Subject: MHI's Response to US-APWR DCD RAI No. 310-2346 Revision 2

MHI's Response to US-APWR DCD RAI No. 310-2346 Revision 2

RAI NO.: NO. 310-2346 REVISION 2
SRP SECTION: 15.04.03 - CONTROL ROD MISOPERATION (SYSTEM MALFUNCTION OR OPERATOR ERROR)
APPLICATION SECTION: 15.4.3
DATE OF RAI ISSUE: 5/04/2009

Figure A.1-1 CRDMCS Configuration

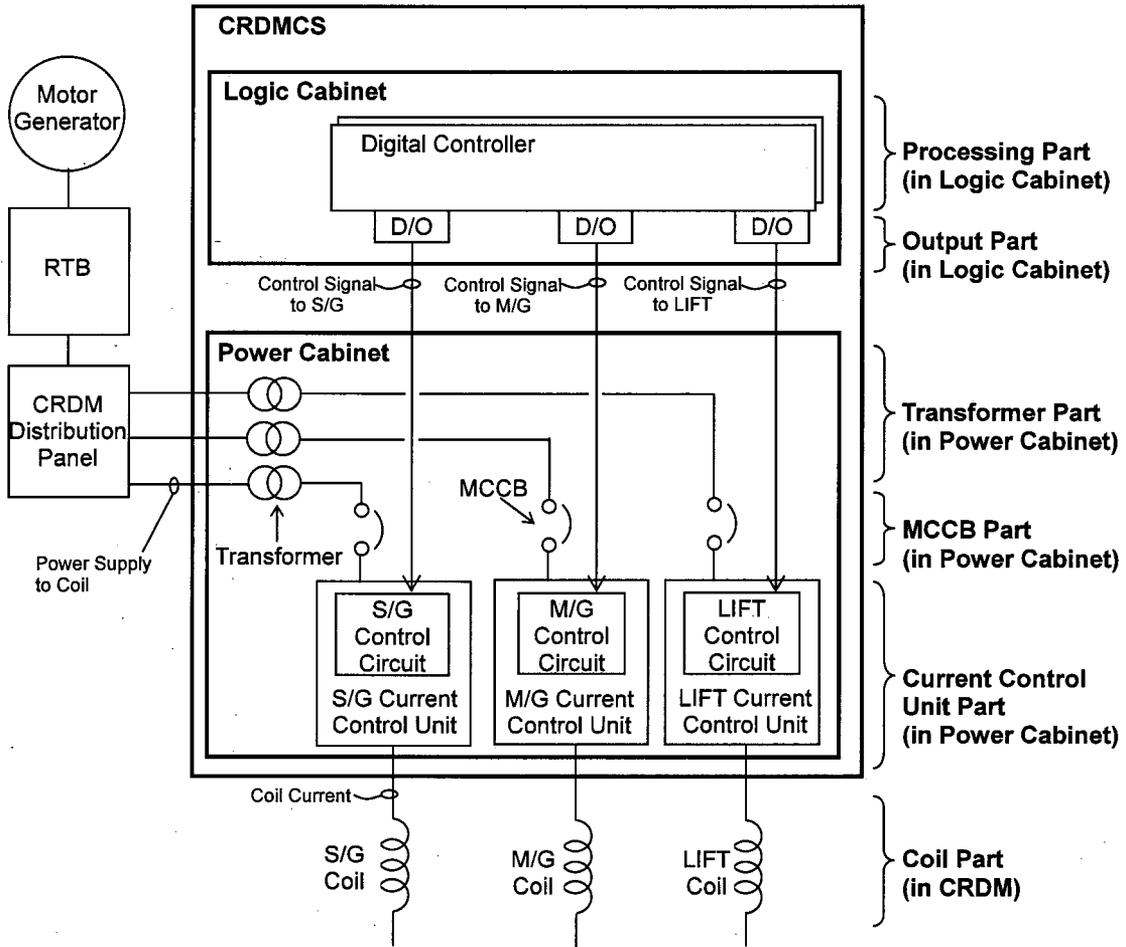
In Section 15.4 it states, "The uncontrolled withdrawal of a single RCCA and the spectrum of rod ejection are classified as postulated accidents (PAs)." Provide explicit details and a probabilistic analysis justifying the reclassification of RCCA withdrawal. Specifically, the staff requests the applicant to provide risk assessment studies and radiological consequences for RCCA withdrawal.

The system for the control rod drive mechanism (CRDM) control is divided into several parts as shown in Figure A.1-1. These divisions are the Logic Cabinet (processing part and output part), the Power Cabinet (transformer part, Molded Case Circuit Breaker [MCCB] part, and current control unit part) in the control rod drive mechanism control system (CRDMCS) and the Coils (stationary gripper [S/G] coil, movable gripper [M/G] coil, LIFT coil).

The CRDMCS in the plant control and monitoring system (PCMS) adjusts the position of the control rod banks in the reactor core. Each control rod bank is divided into two or more groups to obtain smaller incremental reactivity changes per step. The control rod groups within the same bank are moved such that the relative position of the groups does not differ by more than one-step. Each control rod in a group is paralleled so that rods of the same group move simultaneously. Power to the CRDMs is supplied by motor-generator sets. AC power is distributed to the CRDMCS power cabinet through reactor trip breakers (RTBs) and the CRDM distribution panel. The CRDMCS consists of a logic cabinet and power cabinet. The PCMS controller group of the CRDMCS is located within the logic cabinet. The logic cabinet consists of microprocessor-based digital systems with redundant controllers. The controller group controls solid-state CRDM power supplies that are located in the power cabinet. The mechanical part of the CRDM, which consists of the S/G, M/G, and LIFT mechanisms, is actuated by the coil current generated from the control signals from the CRDMCS through the S/G coil, M/G coil, and LIFT coil. These mechanical parts adjust the control rods directly.

There are 69 control rods for the US-APWR. The control rods are controlled bank by bank or group by group. The segmentation of the control rod bank and control rod group is shown in Figure A.1-2.

Figure 15.4.3-8.1 Calculation Flow Diagram of the Number of Rods in DNB Methodology

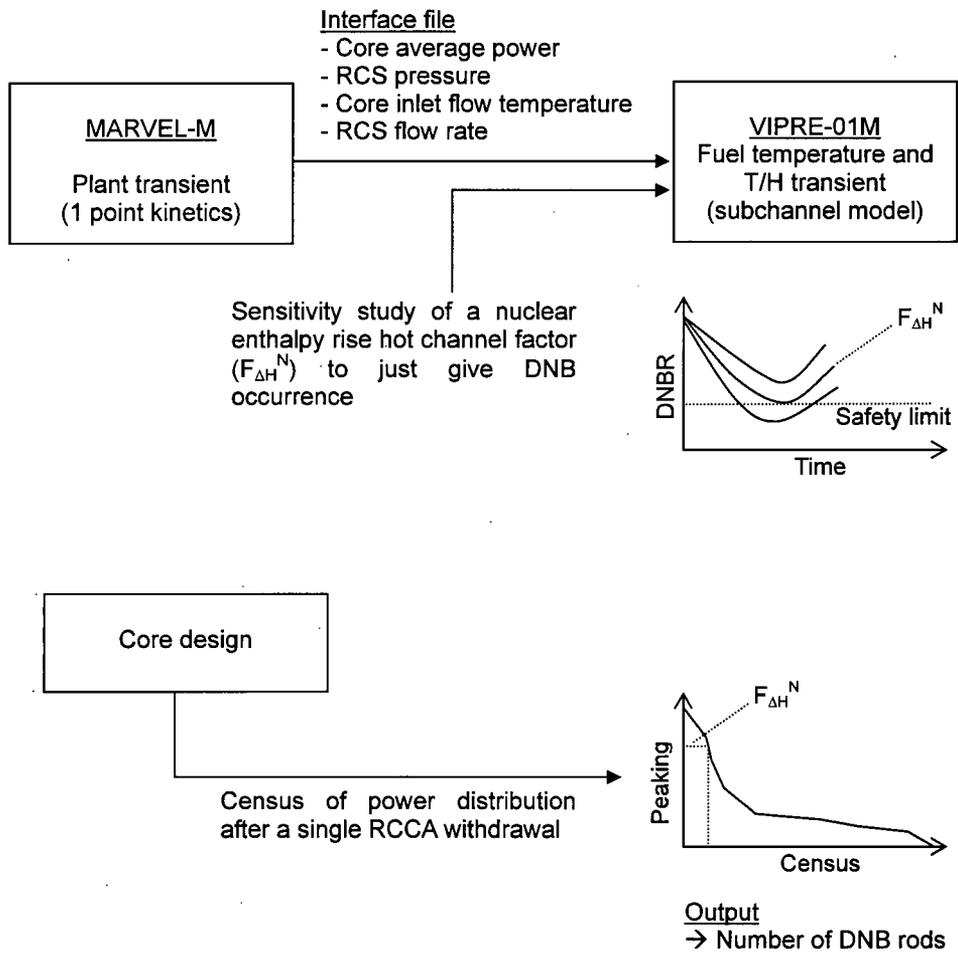
For the withdrawal of a single RCCA, it is understood that the minimum DNBR at the hot spot will not satisfy the 95/95 limits. Discuss how the number of rods below the DNBR limit is obtained?

For this event, a single RCCA is withdrawn and positive reactivity is inserted into the core. The plant transient response for this event is basically the same as for the uncontrolled RCCA bank withdrawal at power event, except that the distortion of the radial power distribution is larger. This is because only one RCCA is withdrawn and there is no symmetry in the radial power distribution in the single RCCA withdrawal. Thus, based on the MARVEL-M input file for the uncontrolled RCCA bank withdrawal at power event, a sensitivity analysis of the heat flux due to the distortion of the radial power distribution is done and a search is performed for the nuclear enthalpy rise hot channel factor ($F_{\Delta H}^N$) that just gives DNB occurrence in the number of rods in DNB evaluation. The number of rods in DNB is obtained by the $F_{\Delta H}^N$ in which the DNBR reaches the safety analysis limit and the $F_{\Delta H}^N$ census curve for this event. The reactivity insertion continues until the reactor trips in the uncontrolled RCCA bank withdrawal at power event, but since the reactivity insertion is a finite value for this event, the evaluation method is conservative. This methodology is the same as the evaluation of the number of rods in DNB for the spectrum of RCCA ejection event which is shown in Figure 5.3-3 of the Non-LOCA Methodology Topical Report (MUAP-07010). The conceptual diagram of the number of rods in DNB evaluation for the single RCCA withdrawal event is shown below in Figure 15.4.3-8.1.

**Figure 15.4.3-9.2 Fuel Temperature versus Time
Uncontrolled Withdrawal of a Single RCCA**

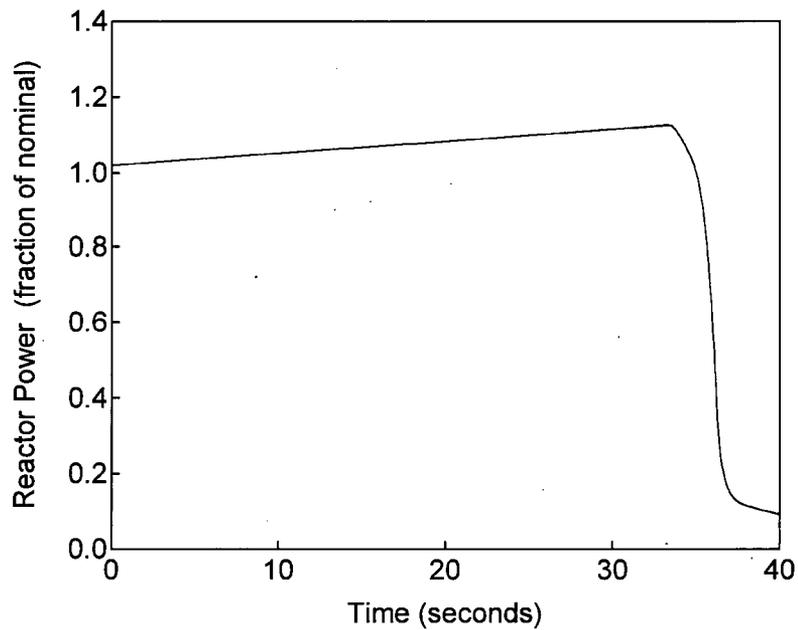
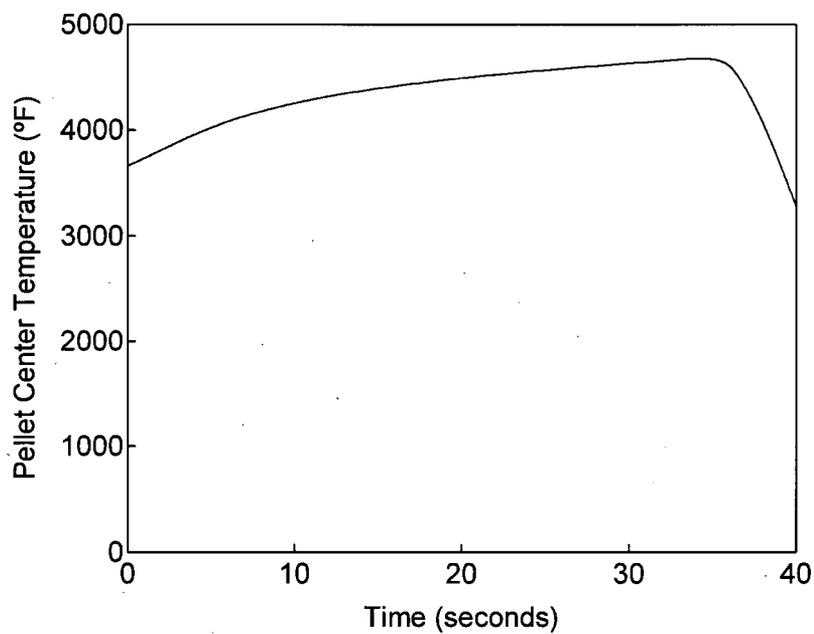
What is the fuel centerline temperature for the withdrawal of a single RCCA?

As stated in DCD Subsection 15.4.3.3.3.3, using a more detailed analysis method, the minimum DNBR is above the 95/95 limit and no fuel failures are predicted. Consistent with the assumption of no DNB, this case was re-analyzed to calculate peak fuel centerline temperature. The initial conditions were changed to estimate the fuel temperature conservatively. The initial power level is 102% of the licensed core thermal power level with an initial reactor coolant temperature 4°F above the nominal value and a pressurizer pressure 30 psi below the nominal value. This combination of uncertainties for the initial conditions maximizes the fuel centerline temperature. The reactivity insertion rate of () maximizes fuel centerline temperature for the case at 100% power. The hot channel factor is assumed to be (). The uncertainty in fuel temperature is added to the fuel initial temperature. The calculation results are indicated below in Figures 15.4.3-9.1 and 15.4.3-9.2 and in Table 15.4.3-9.1. The maximum fuel centerline temperature for this analysis is () which is less than the fuel pellet melting temperature. The fuel pellet melting temperature is a function of burnup and is calculated per the methodology described in DCD Subsection 4.2.1.2.1.
